City of White Rock

WR20-003

RFP for Park Yard Fencing Installation

ADDENDUM #2

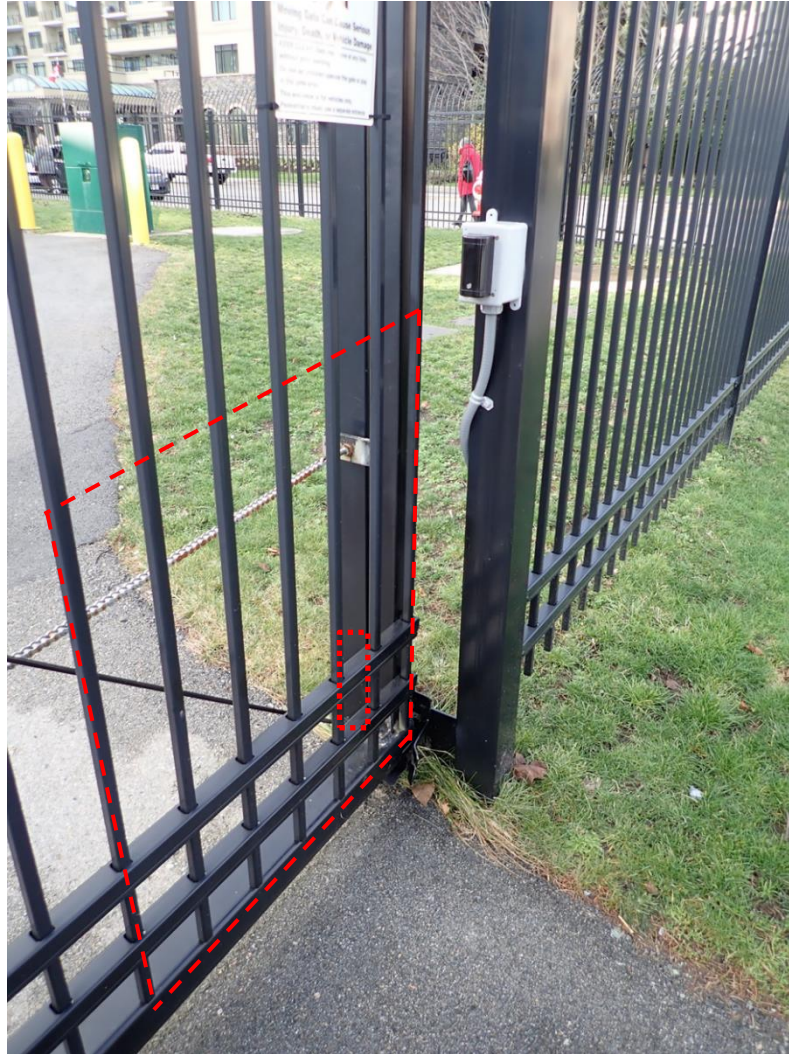
10. Question: Can we use our own access control?

Answer: No. The City uses the Freedom Cube and all access controls need to be tied into this networked control. This provides the City time and date records of everyone accessing any City facility or site.
